RE: Consultation on revised documents for planning applications relating to The Stag Brewery, Lower Richmond Road, Mortlake, London, SW14 7ET; and Chalkers Corner Junction at the Junction of Lower Richmond Road, South Circular and Clifford Avenue, Richmond; in the London Borough of Richmond upon Thames.

GLA ref: GLA 4172, 4172a & 4172b

LPA ref: 18/0547/FUL; 18/0458/FUL and 18/0549/FUL

1.7 This letter forms the Council's formal response to the Revised scheme.

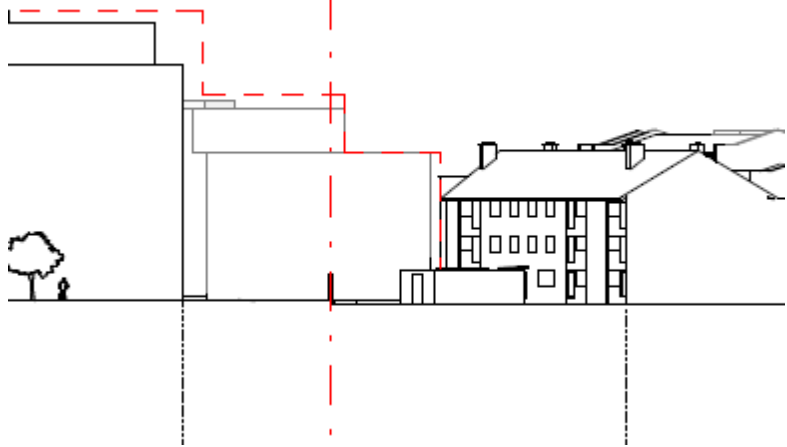
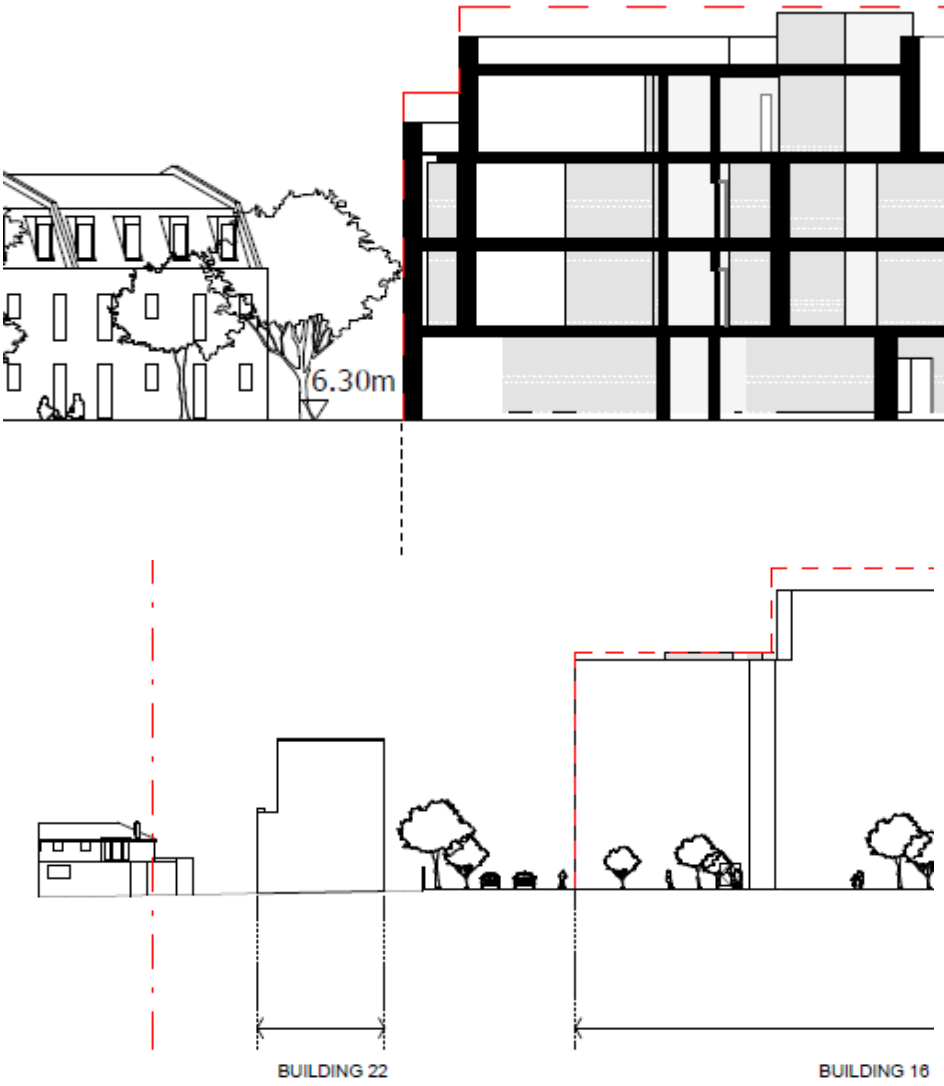
- 3.17 Whilst the January scheme varied from 4, 6 and 7 storeys along the riverside, the Revised scheme proposes three adjacent blocks to have a uniform storey height of 9 storeys, with no reduction towards the river. Whilst these buildings have some variance of roof design, the outcome is a much greater presence and wall of development on the adjacent towpath and River Thames, affecting protected views safeguarded through LP5 (View 2a Mortlake and View 3 Chiswick Bridge) and designated Metropolitan Open Land (MOL), compromising its open character and setting. Policy D9 (f) of the ItP London Plan states that "*buildings near the River Thames, particularly in the Thames Policy Area, should protect and enhance the open quality of the river and the riverside public realm, including views, and not contribute to a canyon effect along the river*".

Relationship of buildings within the development:

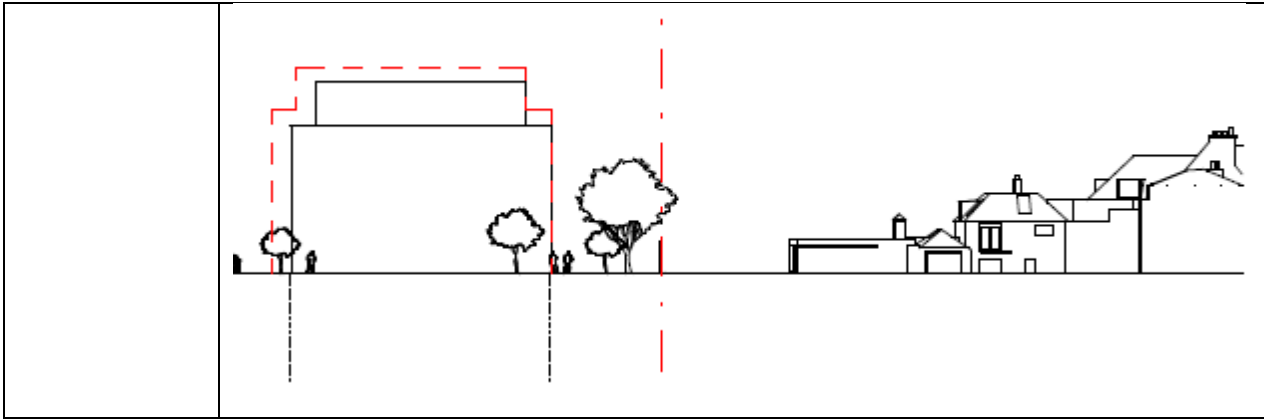
- 3.18 Unlike the development adjacent to the river, which sees no lessening of height, as sought by the adopted PB, the Revised scheme does diminish its height adjacent to Lower Richmond Road and Mortlake High Street, partially due to the retention of perimeter buildings, which are non-designated heritage assets. However, given the significant increase in height of Blocks 2, 7, 8 and 11, and the consequential difference in height with the former bottling plant and hotel (Building 5), the cinema (Building 1) and Building 6, the outcome is an unwelcome juxtaposition. The difference in height is significant, varying between 4 and 5 storeys, some of which are double the storey number of those buildings on the south boundary, and causing an unacceptable visual presence, overwhelming and engulfing the modest scale, character and setting and significance of these heritage assets.
